UNITED STATES ENVIRONMENTAL PROTECTION AGENCY

> Re: BP America Production Company Florida River Compression Facility Title V Permit – Renewal #1 # V-SU-0022-05.00

Enclosure - Response to Comments on the Florida River Compression Facility's March 28, 2008 Draft Title V Permit to Operate

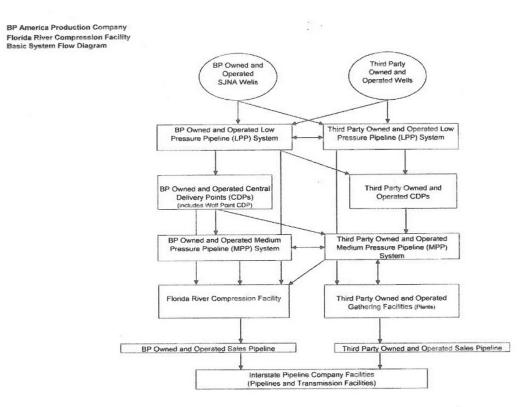
"BP gas" is transferred to third parties or vice versa, the gatherer takes custody of and assumes liability for the gas while in the gatherer's possession, the gas is measured by the gatherer, and the shipper verifies those volumes with its own check meter.²⁸ The following process flow diagram illustrating the flow of gas in the field demonstrates the lack of a unique connection between BP facilities.²⁹
